**TOWN OF MOUNTAIN VILLAGE
REGULAR DESIGN REVIEW BOARD MEETING AGENDA
THURSDAY OCTOBER 3, 2024, 10:00 AM
MOUNTAIN VILLAGE TOWN HALL
455 MOUNTAIN VILLAGE BLVD, MOUNTAIN VILLAGE, COLORADO
TO BE HELD HYBRID THROUGH ZOOM:
<https://us06web.zoom.us/j/89121127945>
Meeting ID: 891 2112 7945**

3.	10:02	30	Nelson/ Applicant	Quasi-Judicial	Consideration of a Design Review: Final Architecture Review for a new single-family detached condominium at Lot 1 Unit 21, Knoll Estates Unit 2, TBD Fairway Dr, pursuant to CDC Section 17.4.11.

TO: Mountain Village Design Review Board
FROM: Drew Nelson, Senior Planner
FOR: Design Review Board Public Hearing; October 3, 2024
DATE: September 24, 2024
RE: Staff Memo – Final Architecture Review (FAR) Lot 1, Unit 21, TBD Fairway Drive, pursuant to the CDC

Figure 4: Site Plan – Proposed Parking

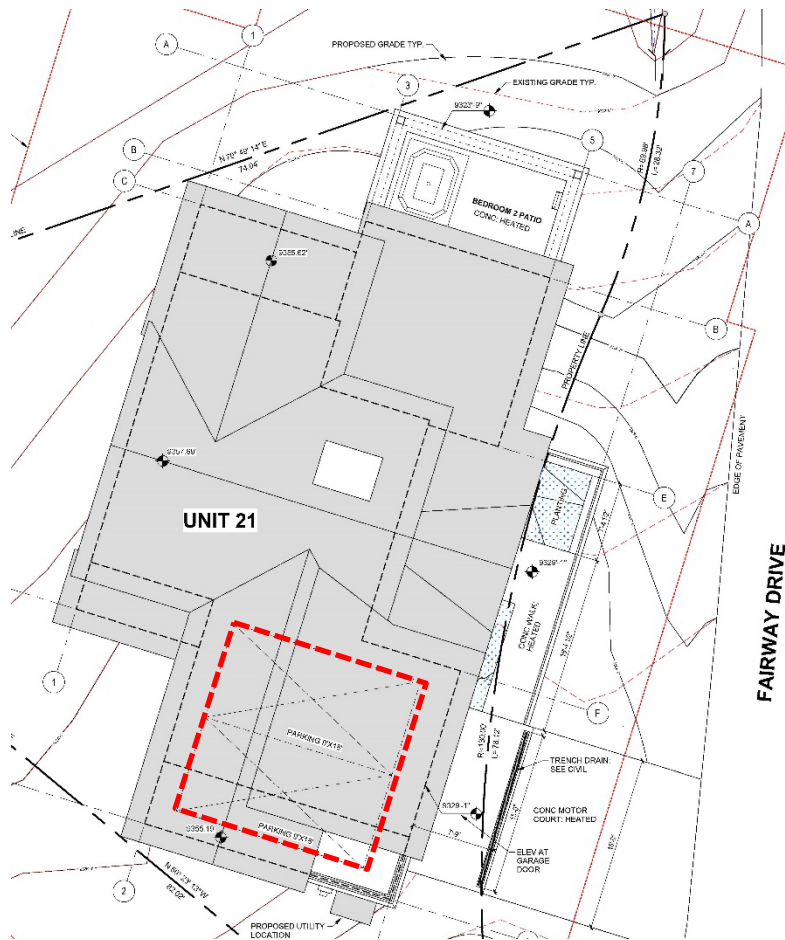
Staff: The proposed design includes two (2) internal parking spaces located in the garage (see Figure 4). Section 17.5.8 of the CDC requires a minimum of two (2) parking spaces for all units located in a Single-family common interest community, which is the official designation of the Knoll Estates subdivision. This design meets the requirements of the CDC.

Figure 5: Landscape Plan

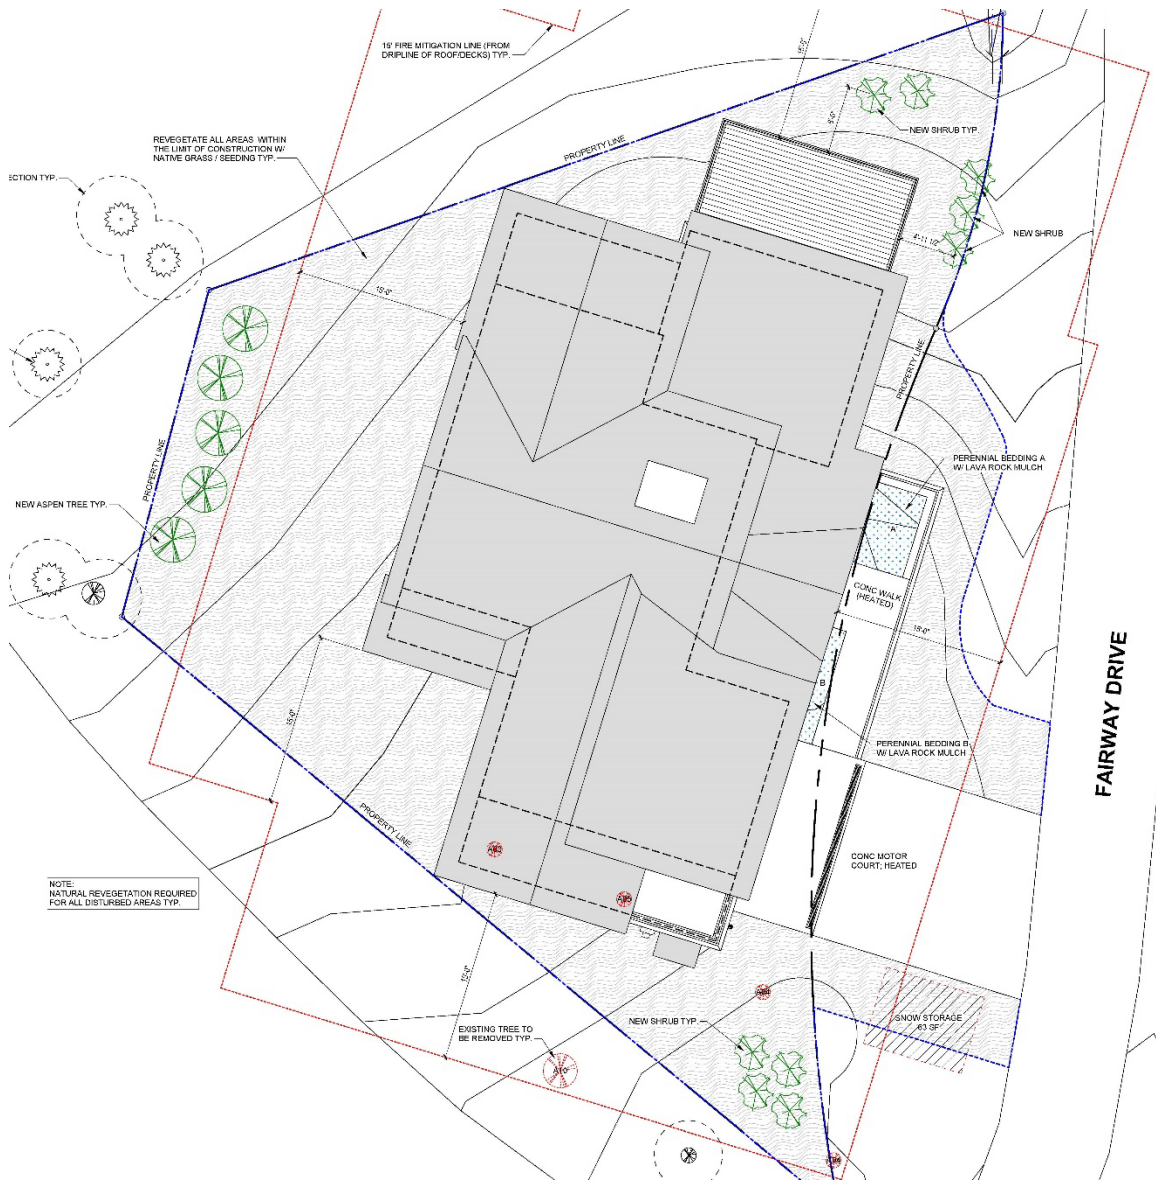
“The landscape plan, sheet A1.3 needs to include a tree planting detail that shows the proper location of the trunk flare in relationship to the grade and other details such as planting hole shape, etc. This sheet also needs a note stating that “all trees to be retained must have tree protection fencing installed at the dripline of the trees or beyond before excavation may begin.

A note needs to be included on the grading or landscape plan that states “A Town of Mountain Village Tree Removal Permit is required before any trees may be removed for development.”.”

All recommendations from the Town Forester were incorporated into the landscape plan prior to Final Architectural Review, which was a requirement of the IASR approval.

C3

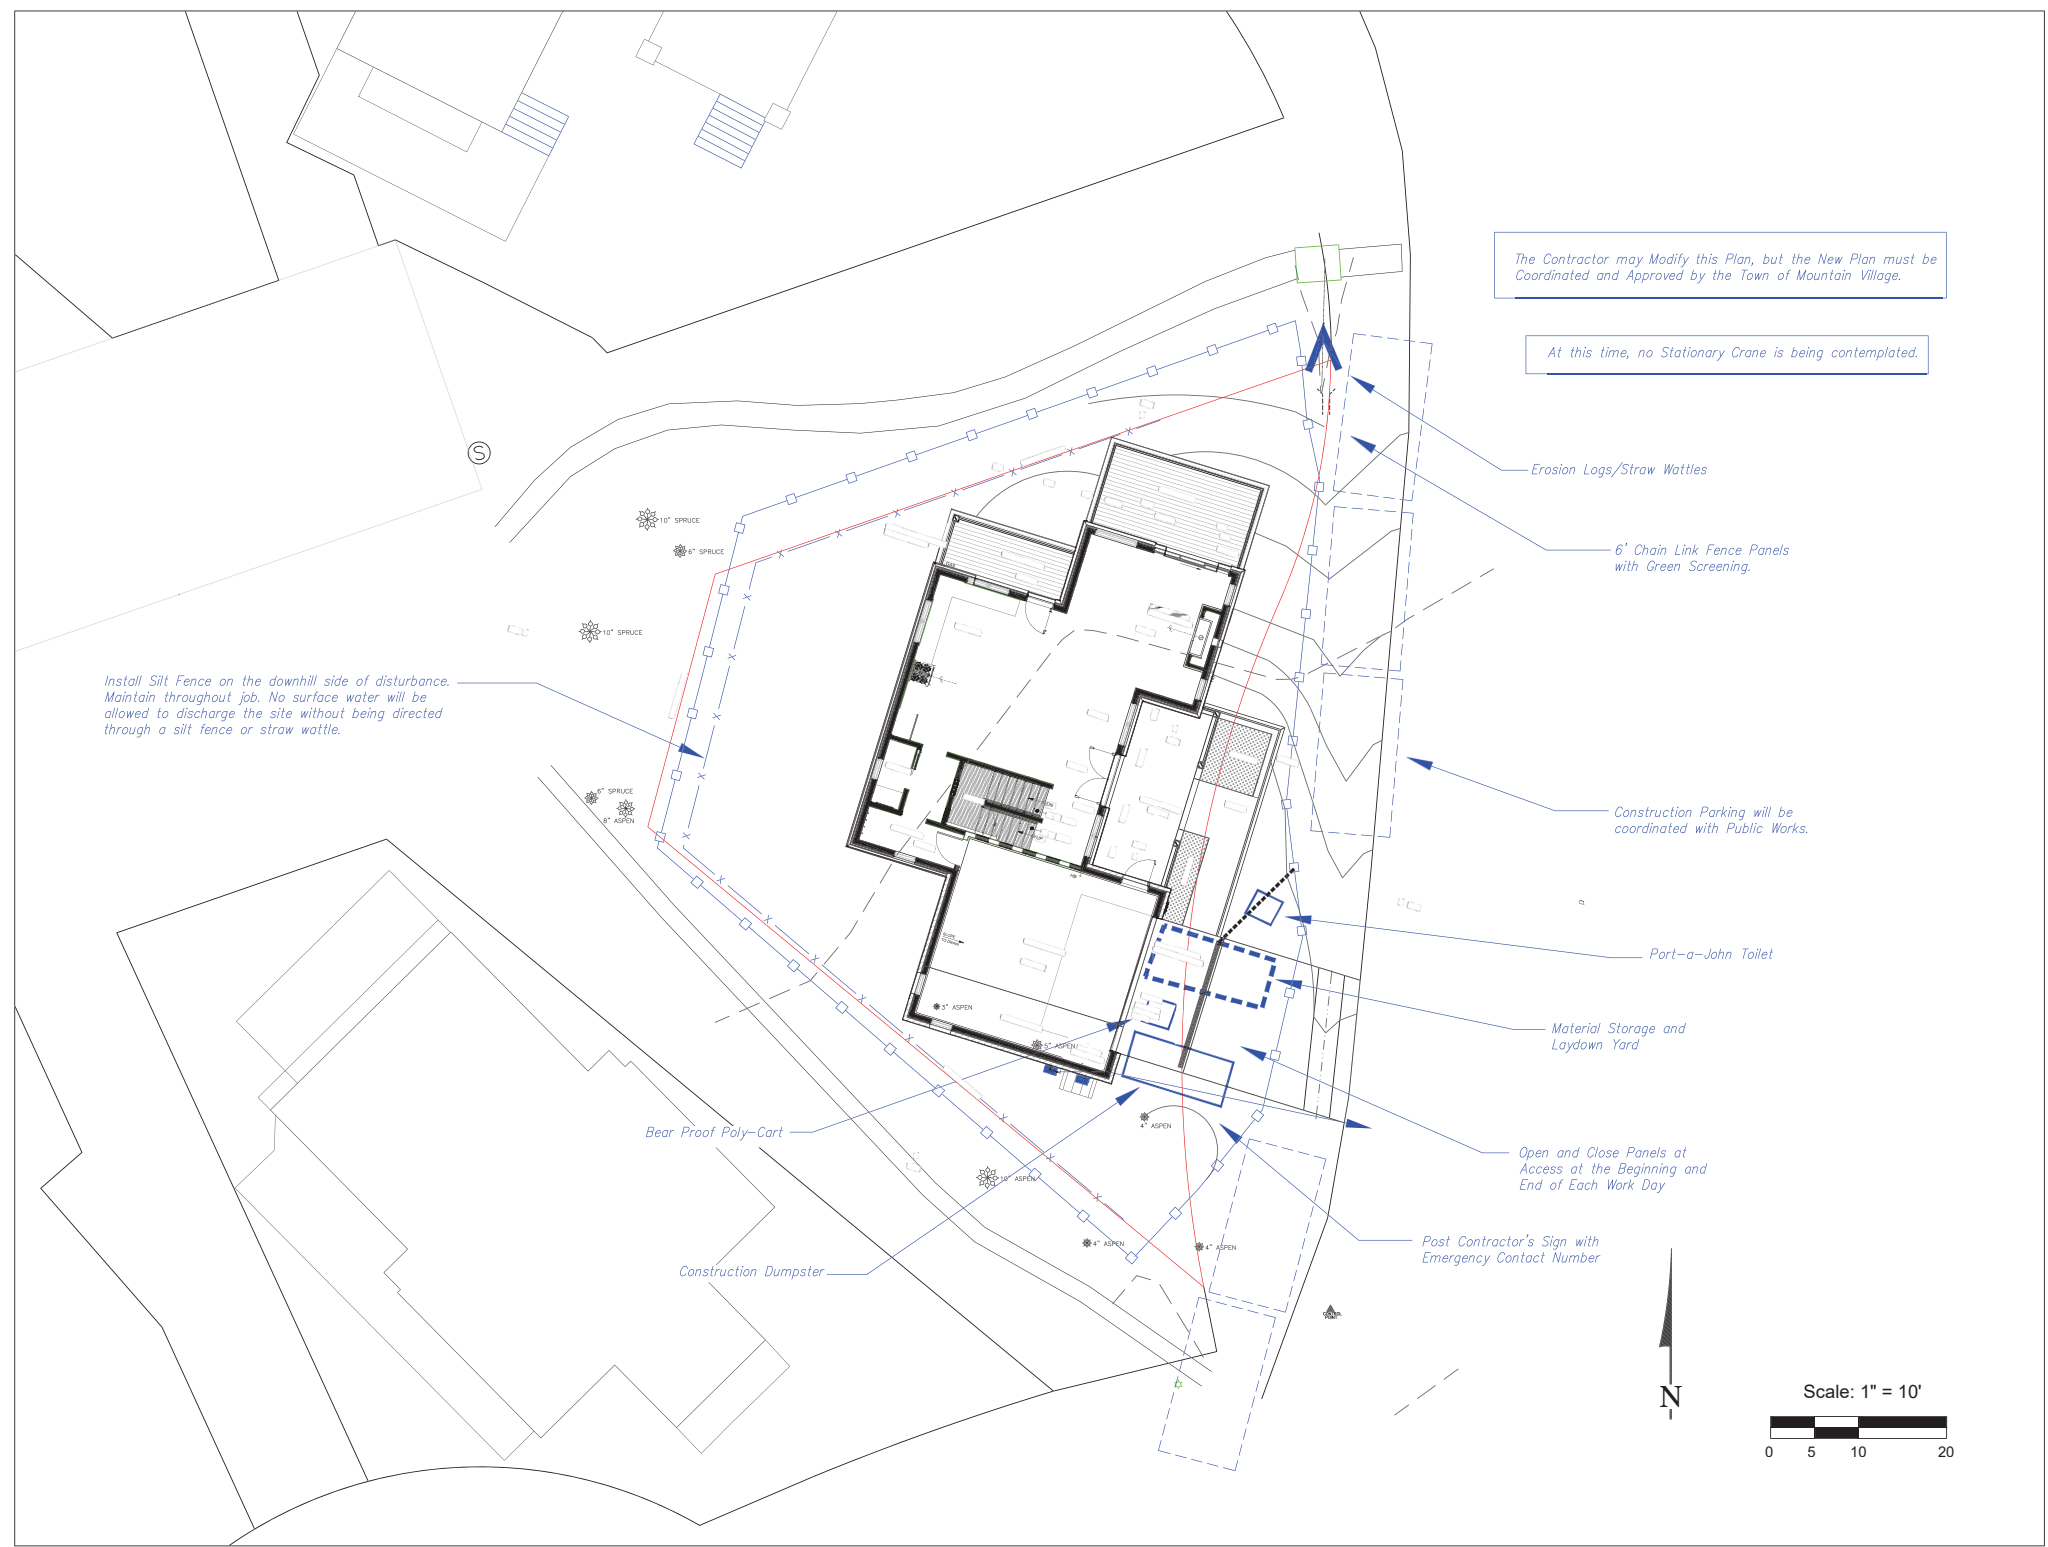
“Parking will be an issue on this one as well. Three spaces indicated on the mitigation plan will not be enough and there are not many other areas to be utilized in this area.

Public Works will need to field verify the location of our water main in the area. Sewer connection looks good.”

The Town's Utility Map indicates that the Water Main may run through the corner of the Lot. Verify with Public Works prior to Construction. The Main may need to be Re-Located.

1 LANDSCAPE PLAN
1/4" = 1'-0"

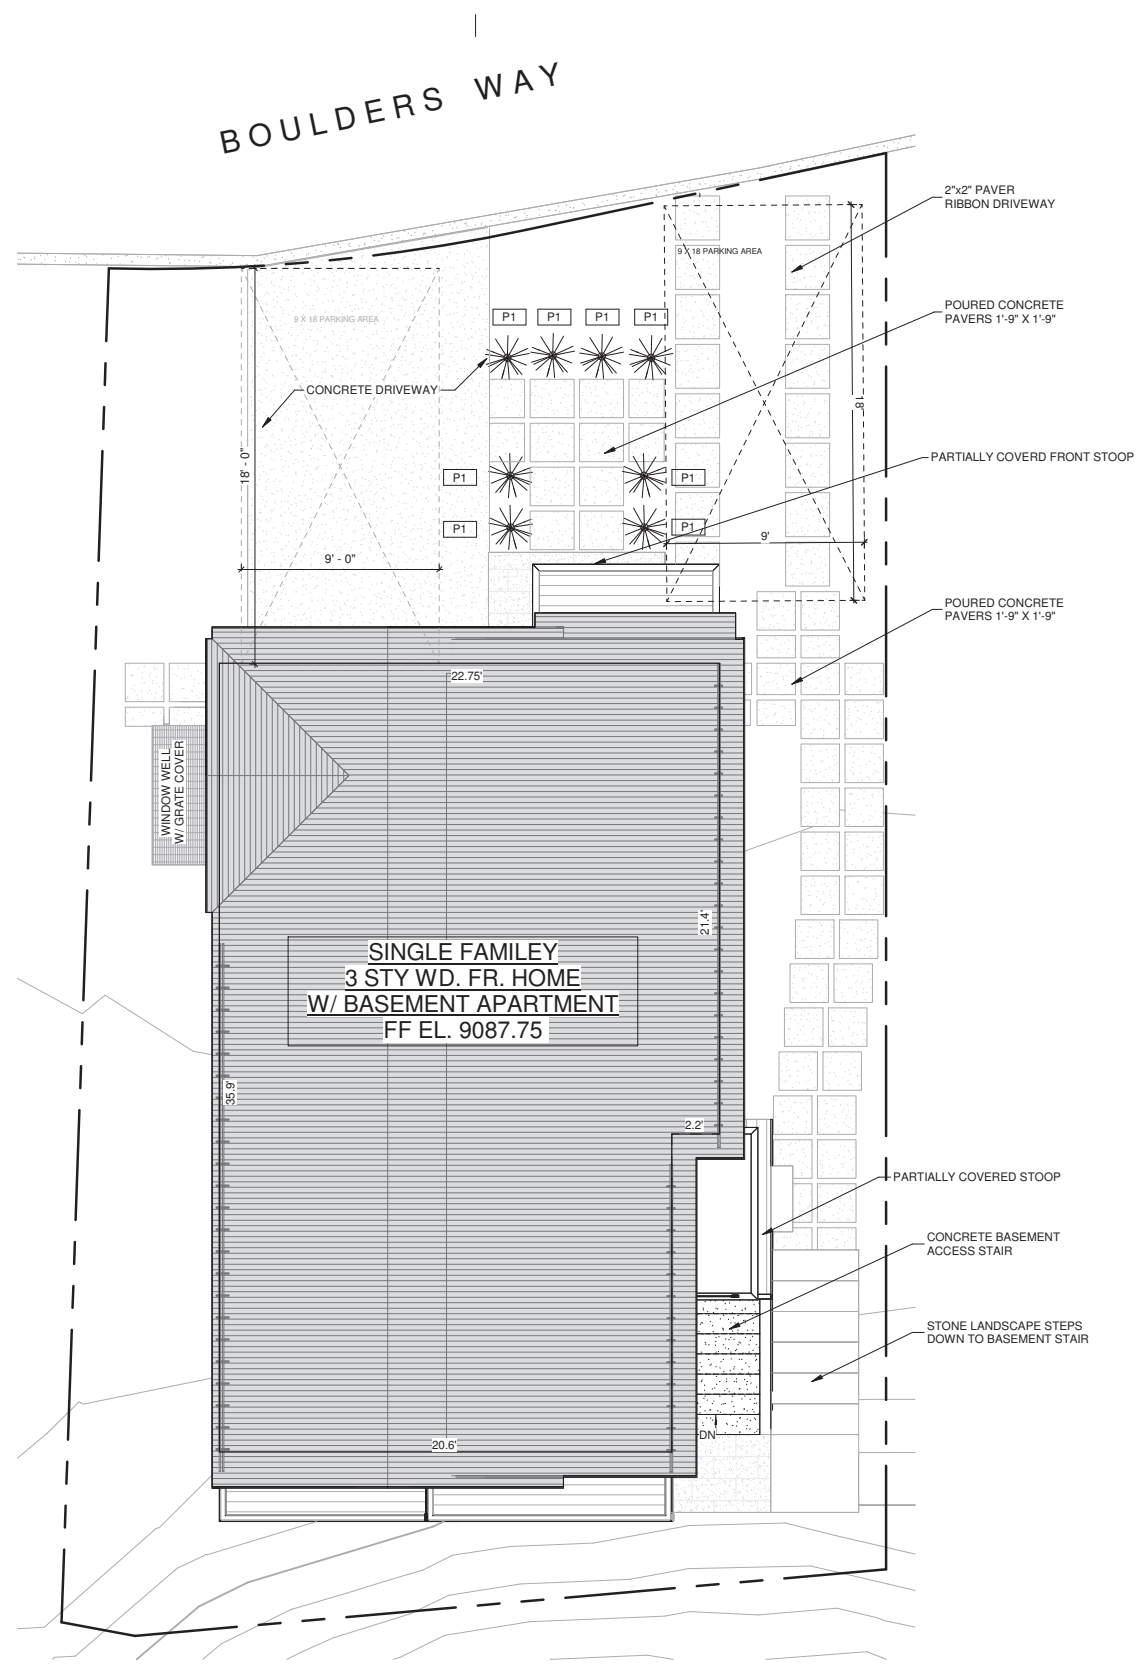
Staff: The applicant has provided a landscape plan on Sheet A1.2. There is no existing vegetation on site. The applicant has proposed 8 Woods Rose bushes on the site. The two Aspen trees were removed from the back corner of the lot. The landscaping plan needs to be revised to include a tree planting detail that shows the proper steps required in planting trees and shrubs.

The plan also needs a note that states that the burlap and wire basket must be removed to at least the top 12 -16 inches of the root ball. The plan should be amended per the Forester's comments prior to building permit.
